NL-07-1308

Edwin I. Hatch Nuclear Plant
Request to Implement an Alternative Source Term
Response to Request for Additional Information Regarding the Unit 1
Main Steam Isolation Valve Alternate Leakage Treatment Path Seismic Evaluation

**Response to Request for Additional Information Regarding the
Unit 1 Main Steam Isolation Valve Alternate Leakage Treatment Path Seismic Evaluation**

Figure 1 Plant Hatch Unit 1 Design Basis Earthquake Ground Response Spectrum vs. One-Half Seismic Margin Earthquake Ground Response Spectrum

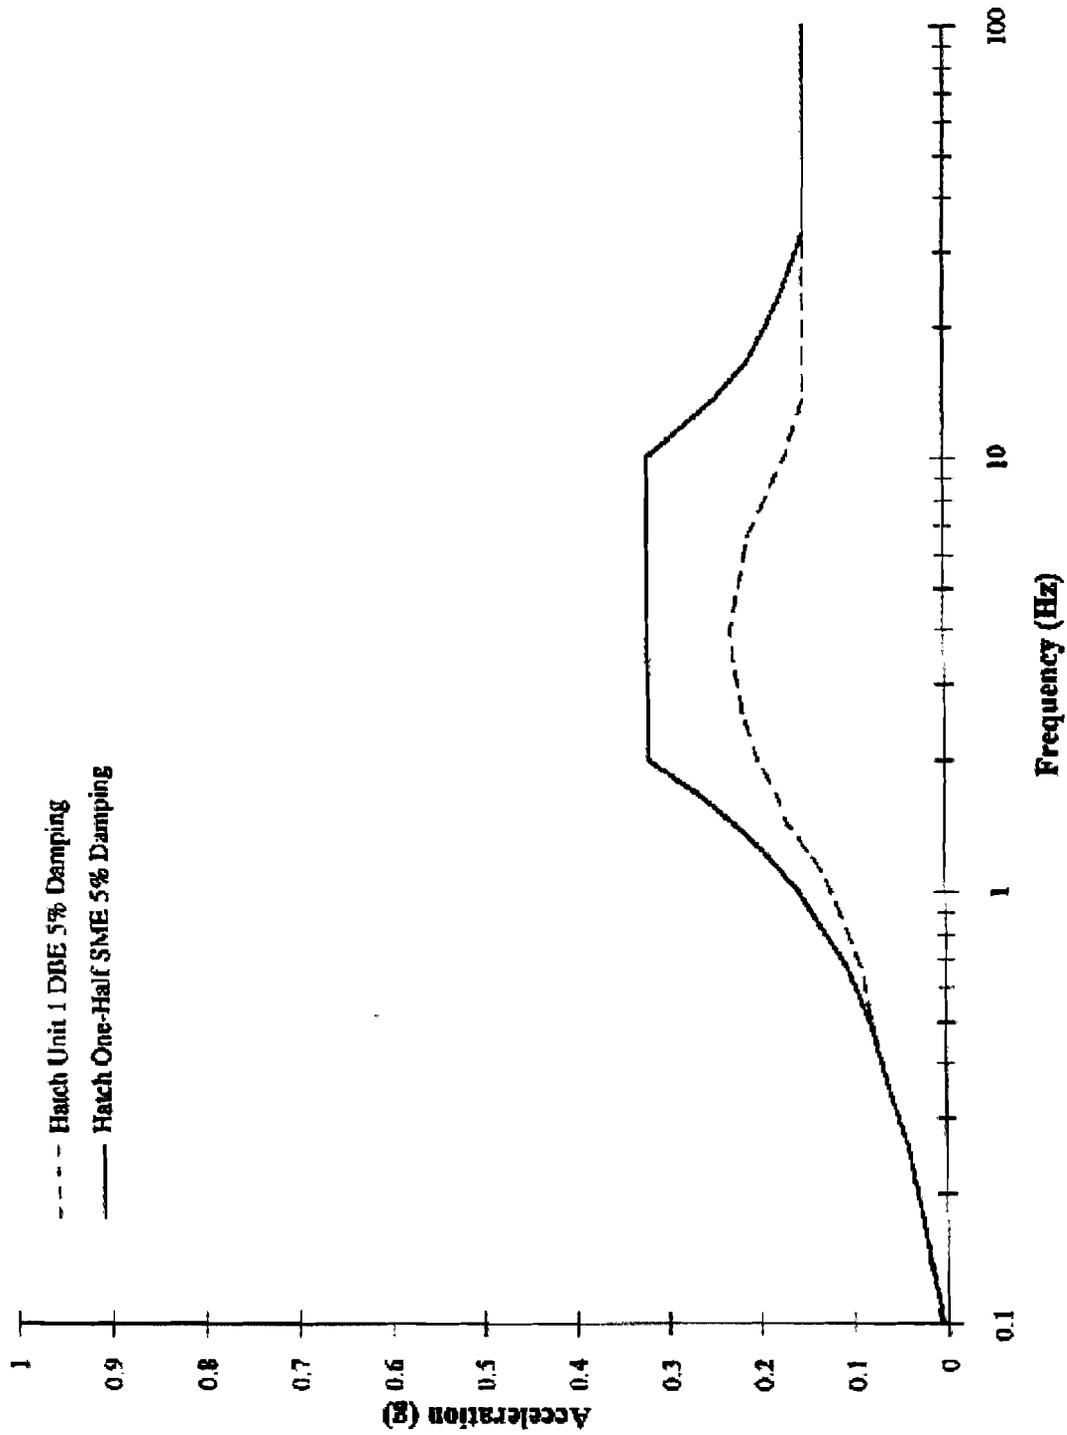
“DW” is dead weight. “Live” is the live load which includes vacuum pressure plus nozzle loads. “½ SME” is the seismic loading based on one-half of the Hatch Unit 1 SME ground motion response spectra. The ½ SME exceeds the required Hatch Unit 1 Design Basis Earthquake (DBE). This exceedance of the seismic spectral acceleration of the Hatch Unit 1 DBE and the resulting conservatism is described in the previous response to NRC question 3 and graphically depicted in Figure 1. The three orthogonal components of earthquake motion were combined by the square root of the sum-of-the-squares (SRSS) rule.
